**From:** Regina Okoye  
**Sent:** Thursday, December 12, 2019 1:24 PM  
**Subject:** FW: Winrock Hotel DRB PR-2019-001579

RE: **Marriot Suites at Winrock  
Conceptual Grading and Drainage Plan Resubmittal  
Hydrology File: J19D0581**

**RE: MARRIOT HOTEL AT WINROCK MALL – DRB PROJECT NUMBER: PR –2018-001579**

SHEET TITLE: PROPOSED HOTEL DEVELOPMENT

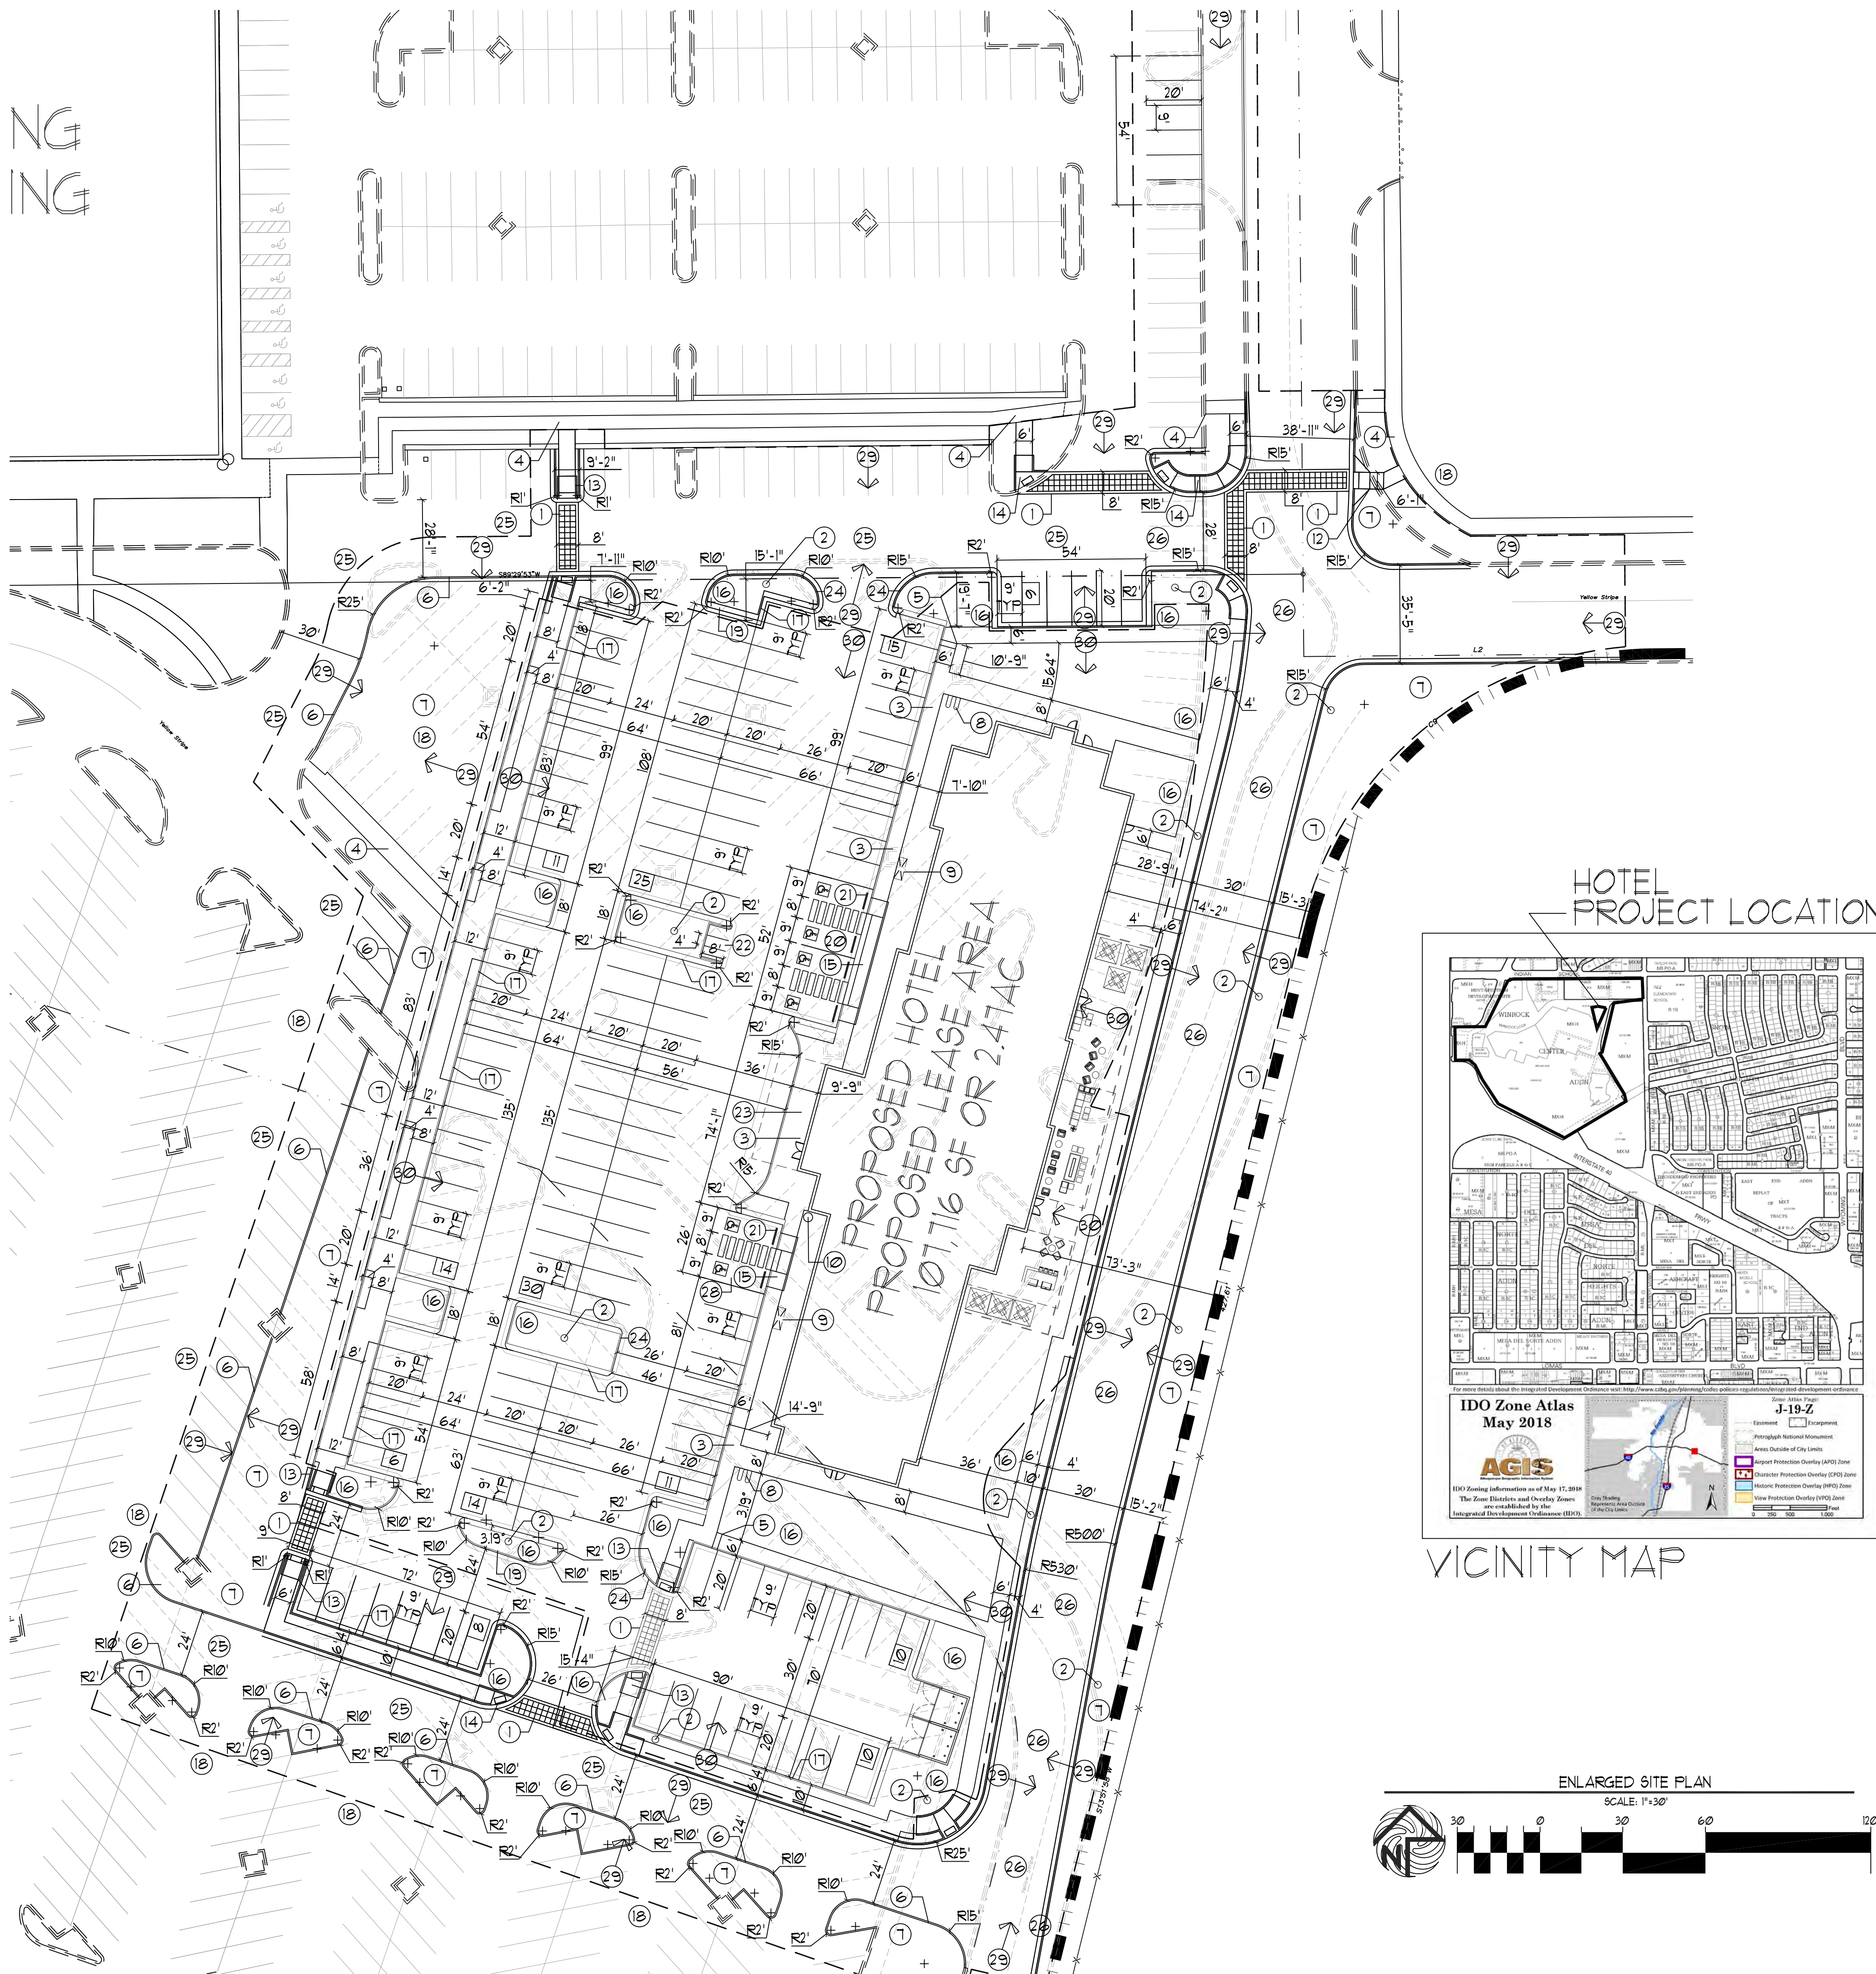
Thank you for your response. I have attached an overall Winrock site plan with the area of the hotel highlighted. I have also included the approved plat in which you can see that there is no public roadway. I just got out of a Winrock infrastructure meeting with Shahab, Maggie and Jeanne related to another issue but this was also reiterated by all in that meeting that this is not a public roadway. Per your request I have included the comments from planning with this question in it.

Thank you for your query and supporting information. I am working on an official interpretation. Please send me a pdf of the site plan so I can verify the proposed building location and the status of the private easement (it could be a callout referencing the private easement on the site plan).

I met with Russell Brito on this issue some time ago. This hotel is internal to the Winrock site and does NOT face a public street. It faces the back side of an apartment complex and is separated by a private access easement as documented. This is NOT a public street.
